MFN 06-262
Supplement 4

Subject: **Modified Reactor Building/Fuel Building Truncated Model,
SER-ESB-038 Rev. 5**

**Shimizu Engineering Report SER-ESB-038, Rev. 5,
“Modified RBFB Truncated FE Model Analysis Data,”**

Project	General Electric Company ESBWR Project	Shimizu Document No.	SER-ESB-038
Title	Modified RBFB Truncated FE Model Analysis Data	Rev.	5
		Issued Date	9/22/06
		Revised Date	1/9/07

Figure C-31 Element Forces Comparison NASTRAN to ANSYS (Basemat Section A-A: Out-of-plane Shear [MN/m])

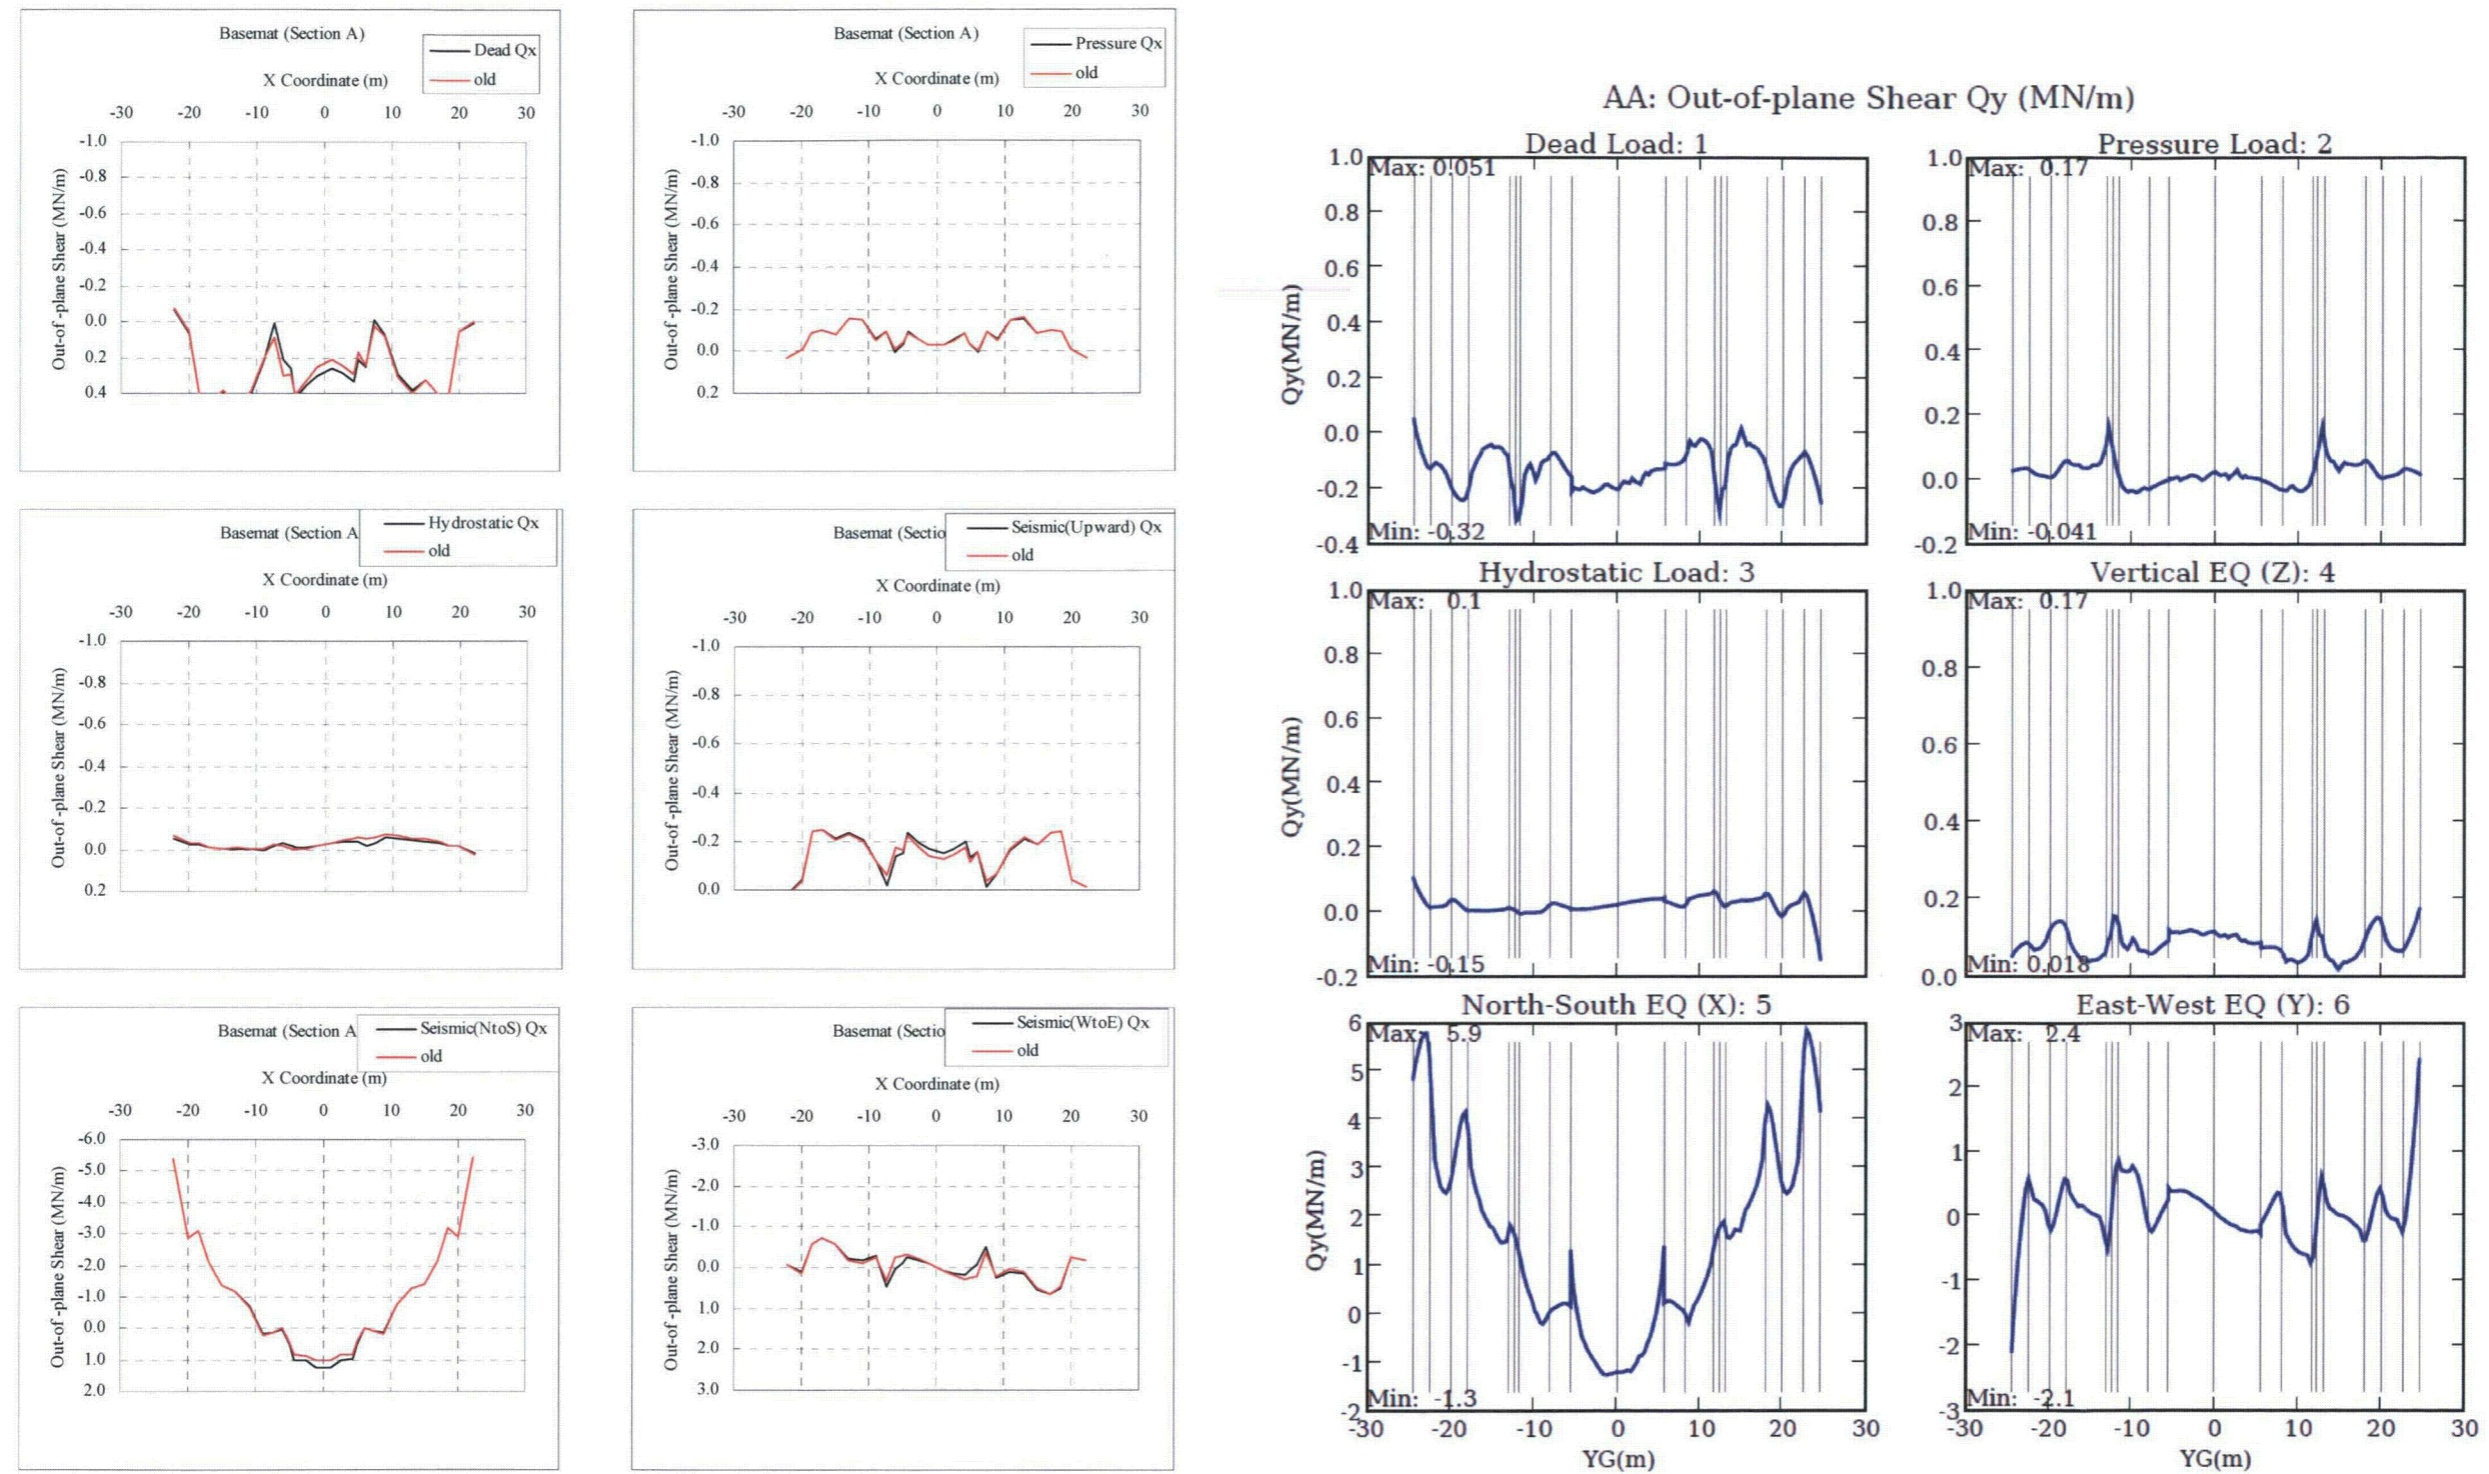
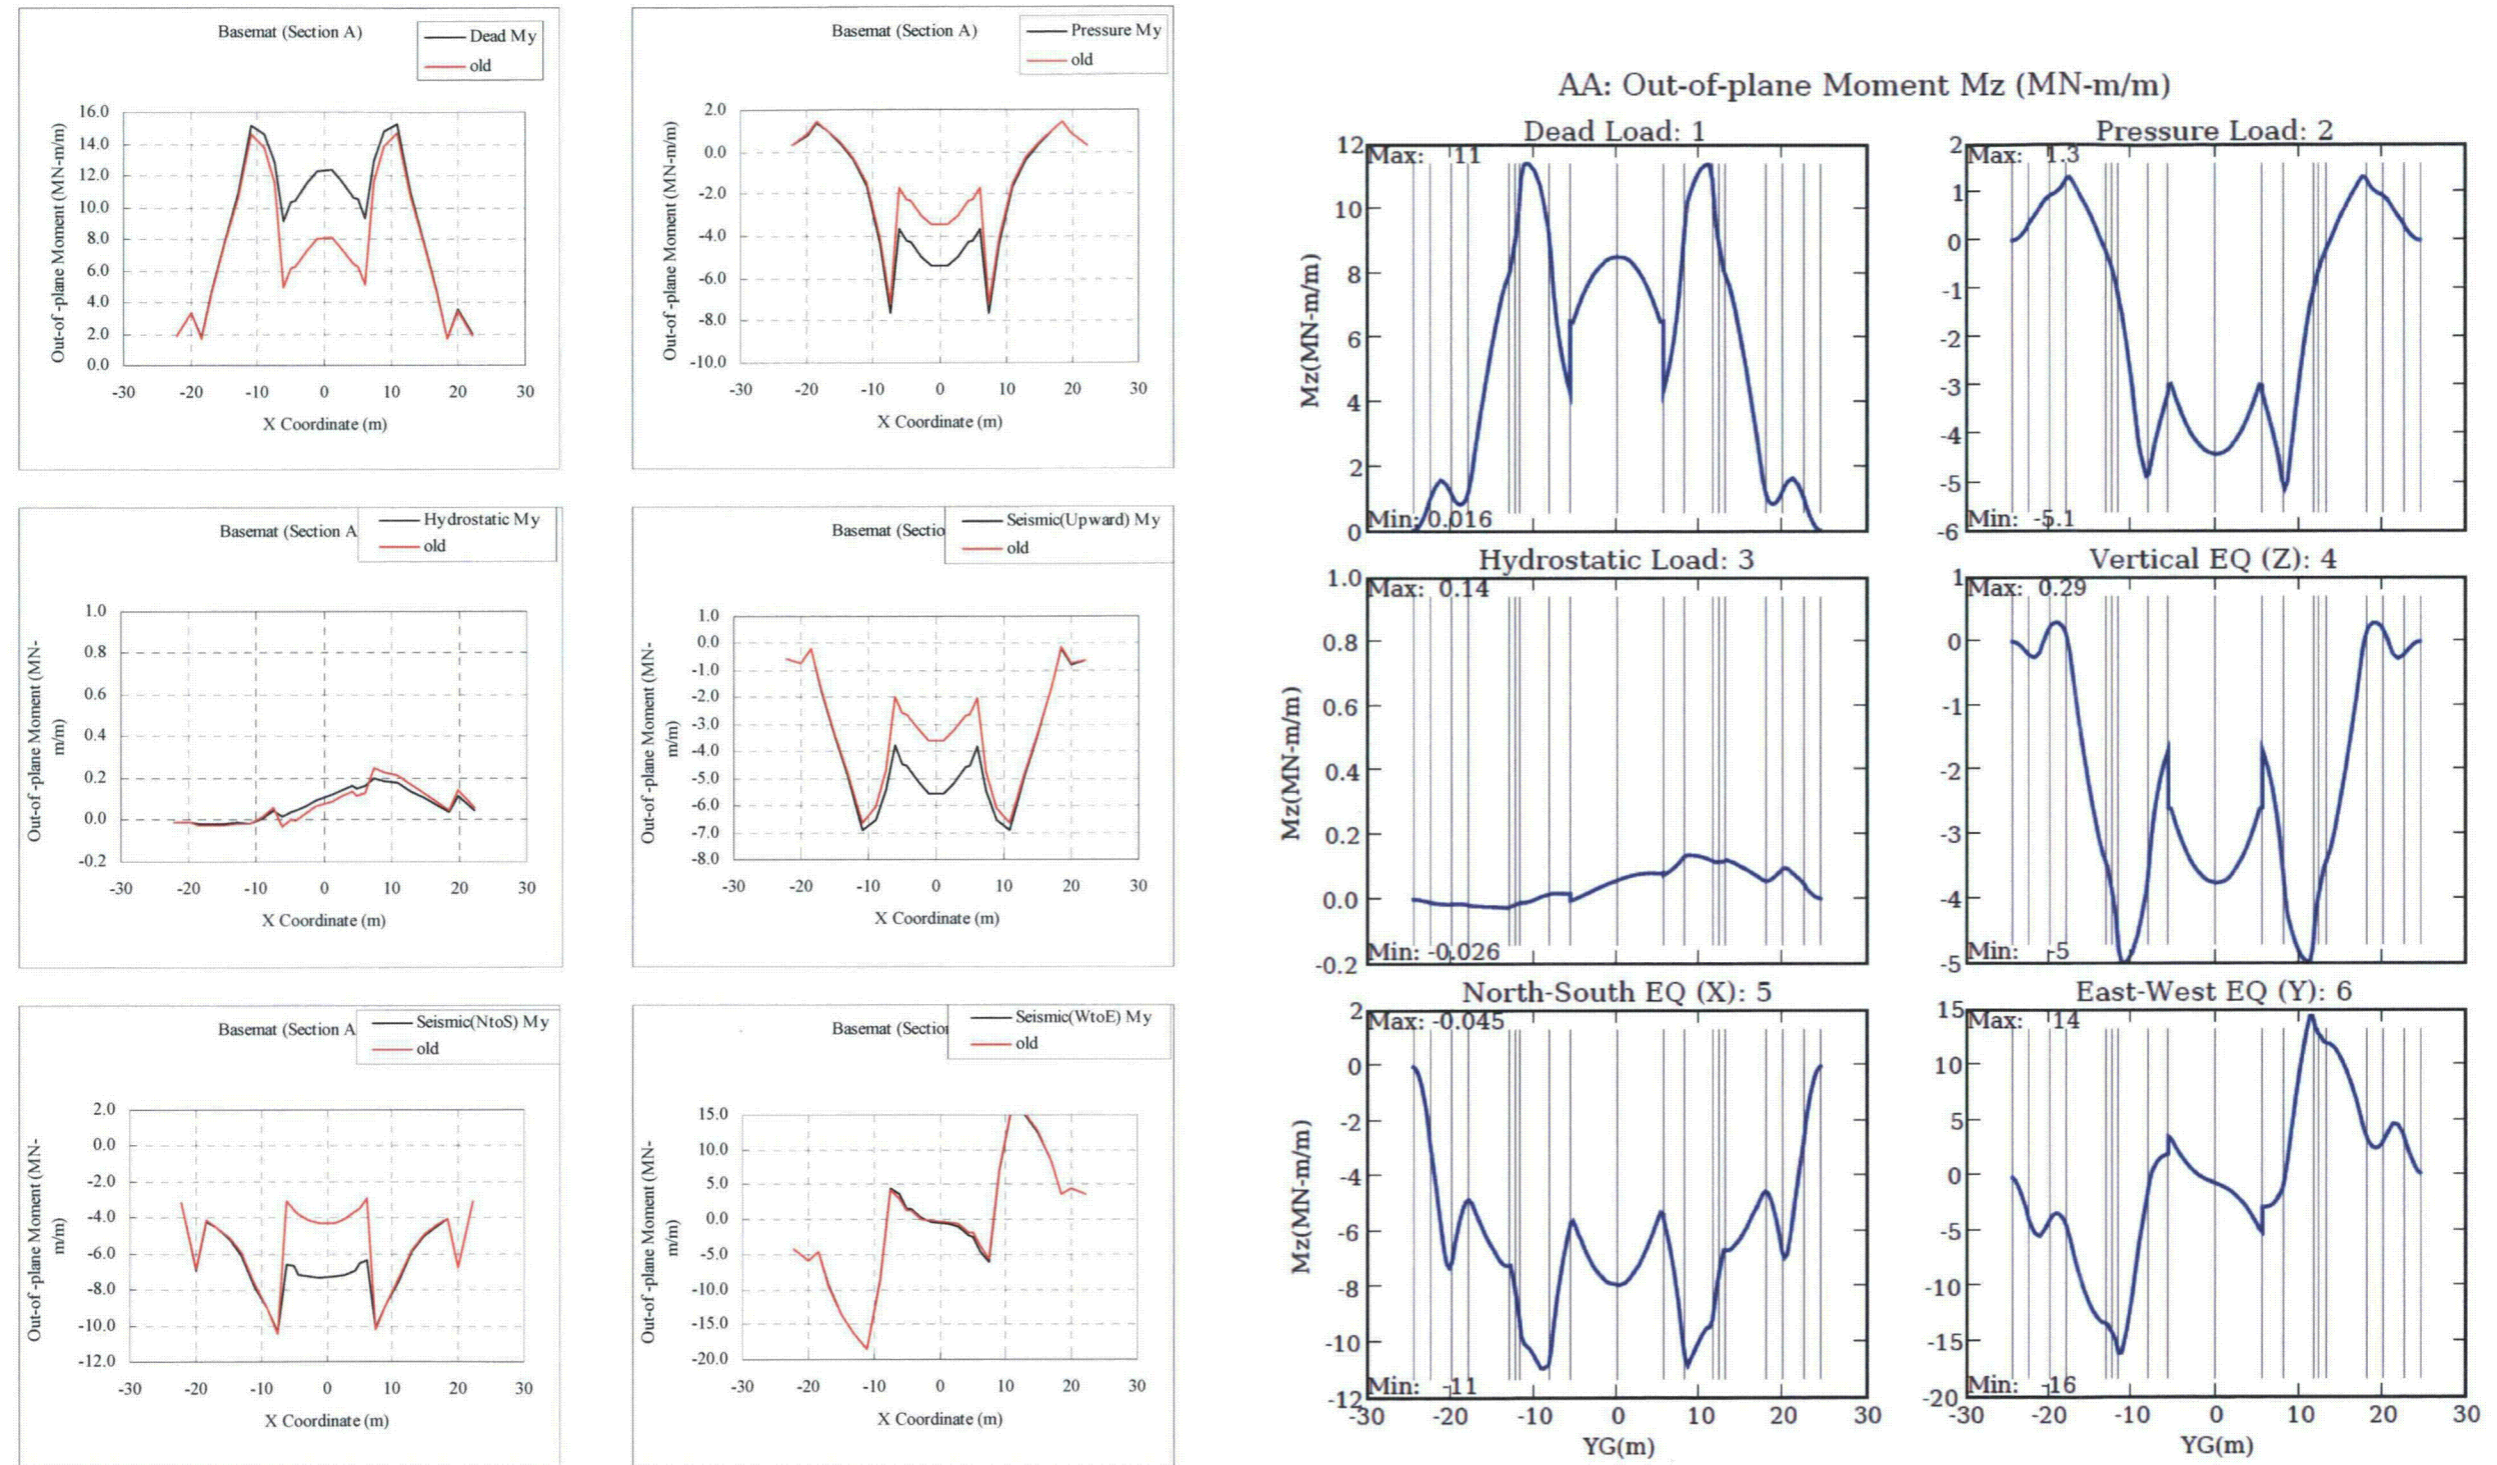
- iii) *The differences of magnitude of forces appeared on basemat inside pedestal:* The result of re-analysis using the updated model shows better agreement. In case of seismic load the magnitude of forces has to be re-compared because BNL's soil spring may not be adequate as pointed out above 3).

- iv) *The differences of magnitude of forces appeared on outer wall of Fuel Storage Pool (FSP):* For the out-of-plane shear forces and moments on RA and F3 wall located around FSP in case of Hydrostatic load, BNL's results are lower than those of GE. GE assumes the some part of differences comes from the difference of estimation levels between both models as pointed out above 8). In order to have a better understanding of the differences, GE would like to request BNL to confirm the input data for Hydrostatic load.
